**Service
Counselor**

PACKARD MOTOR CAR COMPANY

VOL. 26, NO. 6

JUNE, 1952

Fig. 1

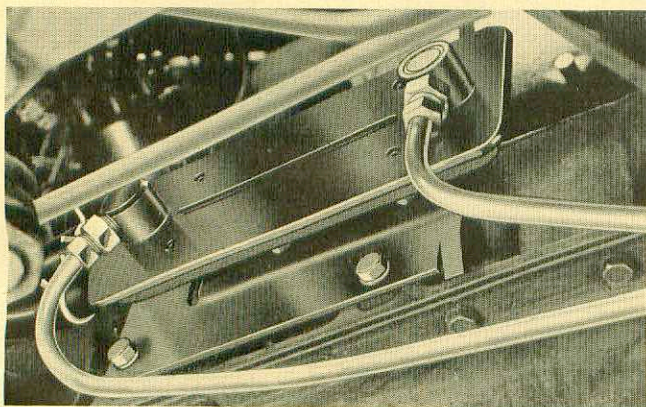
- (c) Install the two oil cooler tube adapters, Part Number 436389, to the oil cooler.
NOTE: Illustration, Figure 2, shows bolt holes in bracket to use for different models. Install the new cooler and bracket on the left side of the upper crank case at the gearshift idler lever support bosses, Figure 1. Do not tighten the bolts until all tube nuts and fittings have been started.

Fig. 3

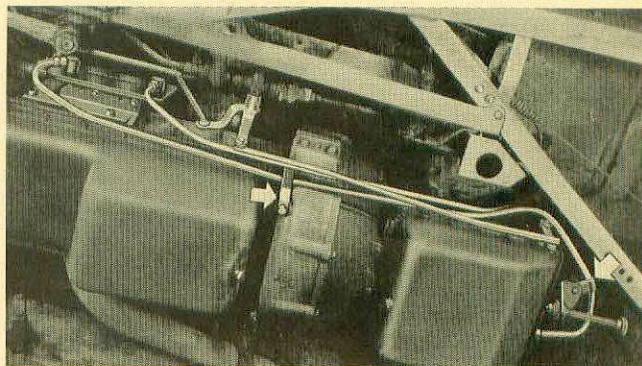
- (d) Install the new tubes as shown in Figure 3. The curved section of the long tube must be inserted over the transmission rear stabilizer before attempting to line it up with the cooler. Start all the tube nuts; be very careful not to cross thread the nuts or adapters.

- (e) Install, but do not tighten the rubber lined tube clip as shown at the flywheel housing. Install the clip on the long tube at the rear where it passes over the stabilizer rod and secure it to the upper end of the stabilizer bolt on the left side of the front stabilizer bracket, Figure 3.
When correct alignment of the tubes and cooler has been obtained, tighten the cooler bracket bolts, all the tube nuts, and the tube clips. Install the control rod to the rear lever and secure with cotter pin.

Fig. 4

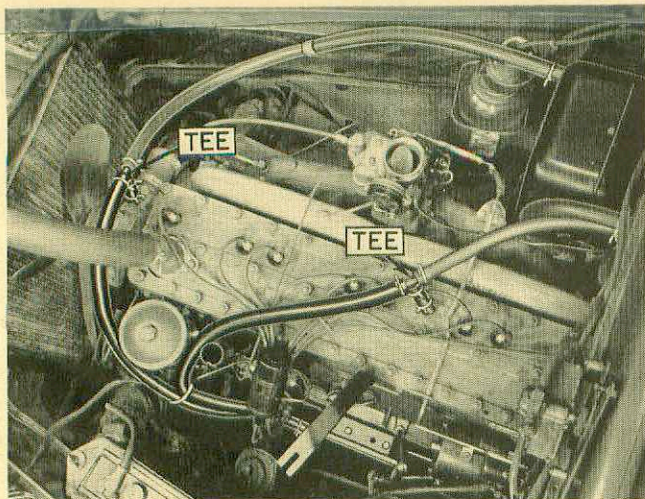
Cut two pieces of hose $2\frac{1}{4}$ " long from the hose furnished in the kit. Install the two short pieces of hose and the two tees to the water pump and cylinder head adapters, Figure 4. Cut about 1" off the heater hoses to get a good connection and reconnect the heater hoses to the tees. Cut in half the balance of the heater hose furnished and install these two hoses from the two tees to the oil cooler, Figure 4. The hoses at the cooler can be connected on either connection. Position the hoses as shown in Figure 4 and fasten together with the strap clamp. Run the car in reverse for a short period and recheck all con-
